Form 3160-5  
(June 2019)UNITED STATES  
DEPARTMENT OF THE INTERIOR  
BUREAU OF LAND MANAGEMENTFORM APPROVED  
OMB No. 1004-0137  
Expires: October 31, 2021**SUNDRY NOTICES AND REPORTS ON WELLS**  
**Do not use this form for proposals to drill or to re-enter an abandoned well. Use Form 3160-3 (APD) for such proposals.**5. Lease Serial No. **NMNM43562**

8. Well Name and No. **CASCADE 29 FEDERAL/15H**9. API Well No. **3002546355**10. Field and Pool or Exploratory Area  
**Purple Sage/WC-025 G-09 S253309P; UPR WOLFCAN**11. Country or Parish, State  
**LEA/NM****12. CHECK THE APPROPRIATE BOX(ES) TO INDICATE NATURE OF NOTICE, REPORT OR OTHER DATA**

Cimarex Energy Co. respectfully requests to change the APD as follows:

WELL LOCATION AND ACREAGE DEDICATION PLAT

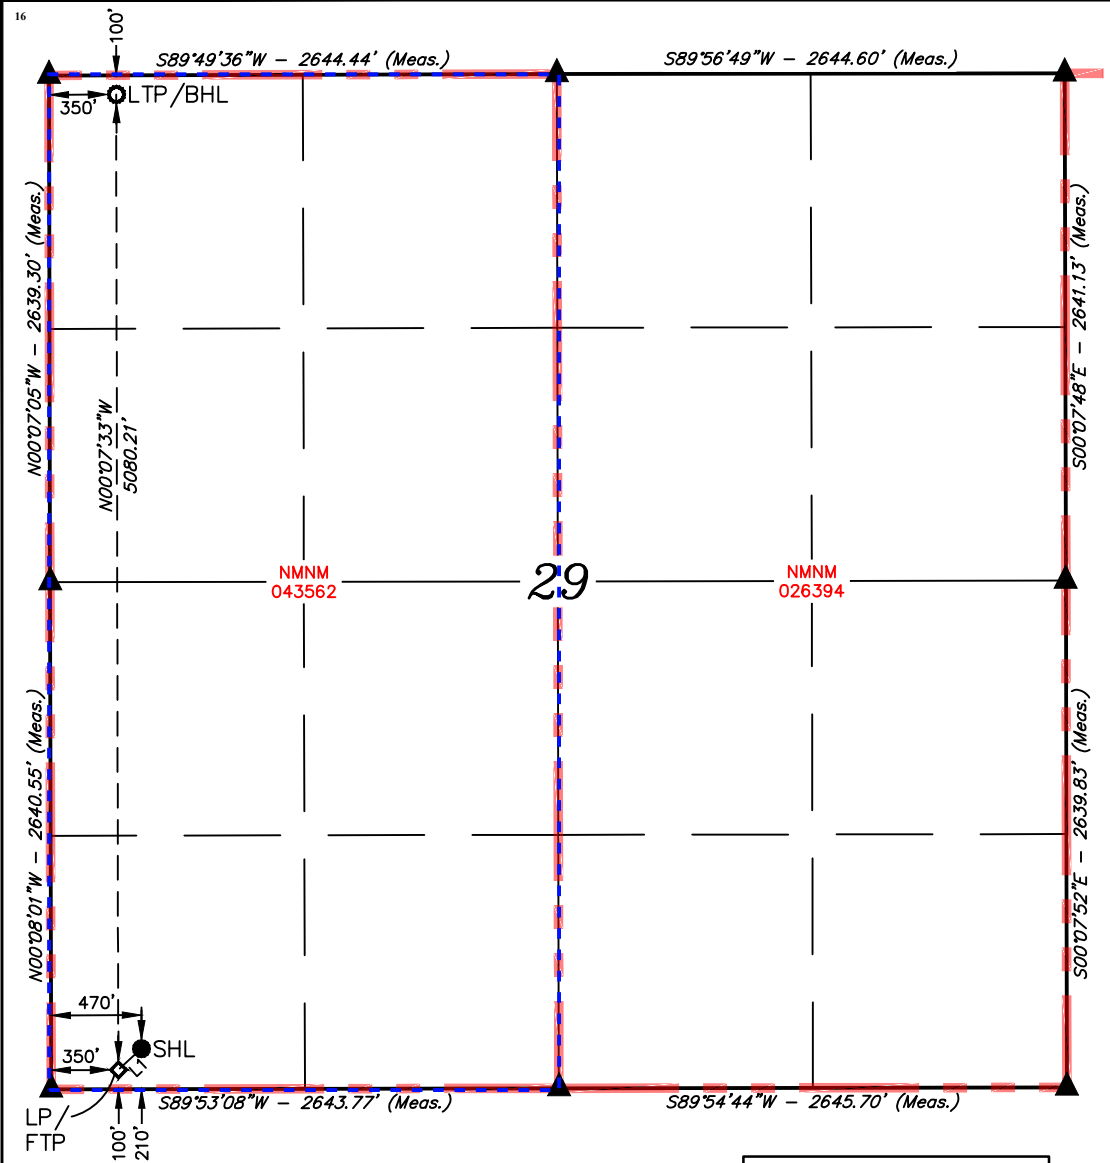
SHL/KOP Current: Unit M, Sec 29, T25S, R33E, 390 FSL & 370 FWL  
SHL/KOP New: Unit M, Sec 29, T25S, R33E, 210 FSL & 470 FWL

FTP Current: Unit M, Sec 29, T25S, R33E, 390 FSL & 330 FWL  
FTP New: Unit M, Sec 29, T25S, R33E, 100 FSL & 350 FWL

LTP/BHL Current: Unit D, Sec 29, T25S, R33E, 100 FNL & 330 FWL  
LTP/BHL New: Unit D, Sec 29, T25S, R33E, 100 FNL & 350 FWL

TVD/TD Current: 12,430TVD, 17,135MD

TVD/TD New: 12,520TVD, 17,331MD

DRAWN BY: C.M.T. 08-07-18  
REV: 2 02-07-23 D.M.C.  
(SHL, FTP & BHL MOVE)
